Conference Call to Discuss Quad Cities ISI Program re: CRD Welds

QUAD CITIES CRD HOUSING WELDS CODE OF RECORD AND DESIGN SPECIFICATIONS

ADDITIONAL INFORMATION 11/01/02

CONTROL ROD DRIVE HOUSING

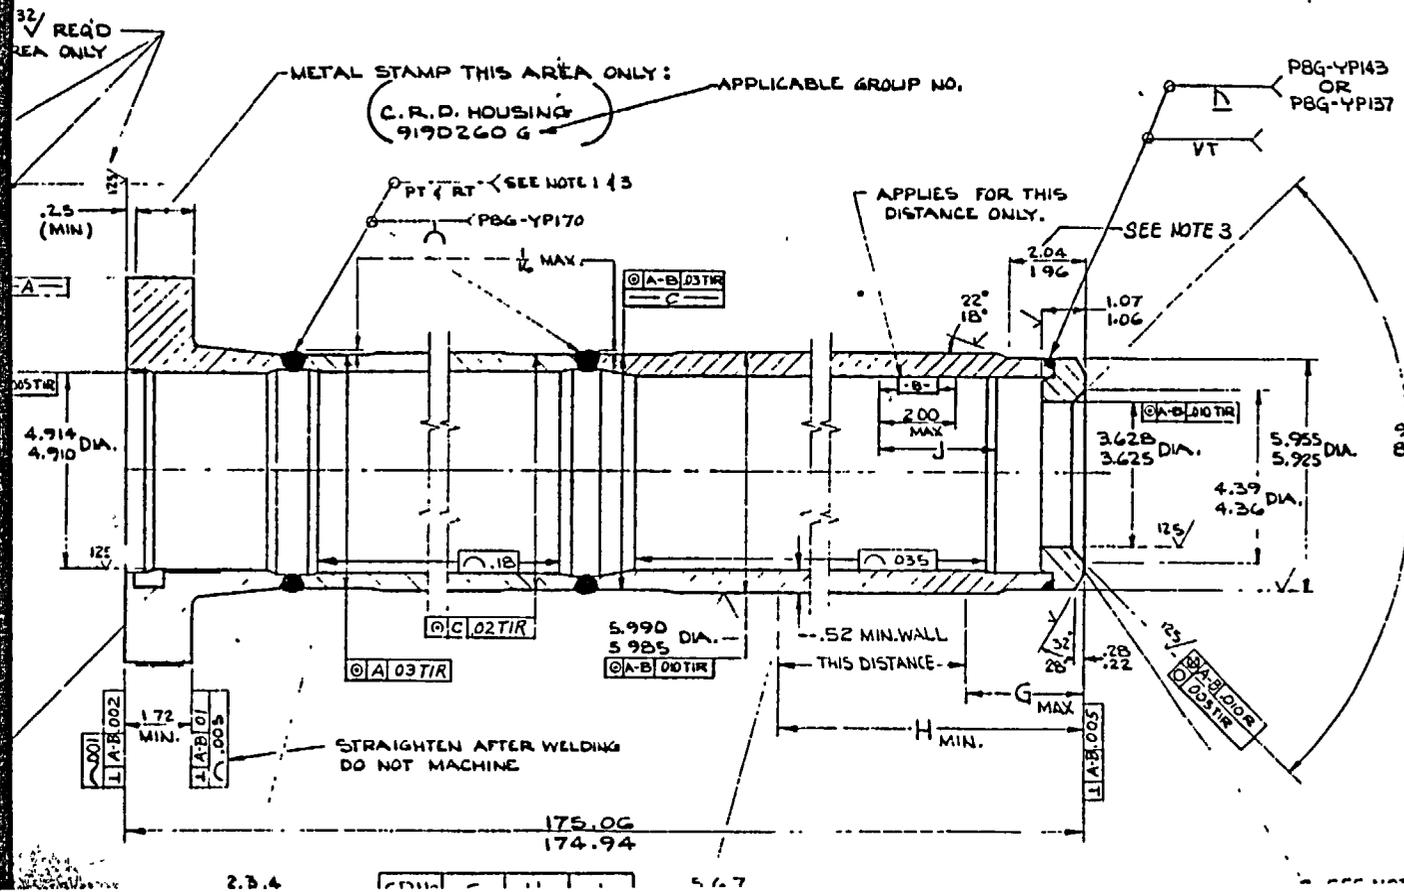
Note¹ from drawing 919D260, for the control rod drive housing welds (this corresponds to the attached simplified drawing welds CRDH 3 and 4) require inspection in accordance with ASME BPV Section III 1965 Edition, Paragraph N-462.2(a) (i.e., Category B welds).

The control rod drive housing welds as described in the design specifications for inspection of welds are considered communicating chambers and are appurtenances to the vessel. Therefore, the welds are not part of the reactor vessel, and ASME Section XI 1989 Edition, Subsection IWB 1220 "Components Exempt from Examination" Category B-O Housing welds may be invoked.

During the call, the staff stated that it had reviewed the information provided and concluded that Section XI, Table IWB-2500-1, Category B-O, Item B14.10 (Reactor Vessel - Welds in CRD Housing), applies to the Quad Cities CRD housing welds. Therefore, the welds should be included in the ISI program.

The licensee stated that they agreed that Table IWB-2500-1 applied to the CRD welds, but their interpretation was that the exemption of IWB-1220 also applied. The staff stated that IWB-1220 does not apply, because the CRD housing is considered part of the reactor vessel. The staff has discussed the issue with members of the applicable Code committee. Also, the staff is aware that PWRs and at least some BWRs (e.g., Fermi) include the welds in their ISI programs. The licensee may, of course, pursue a Code interpretation.
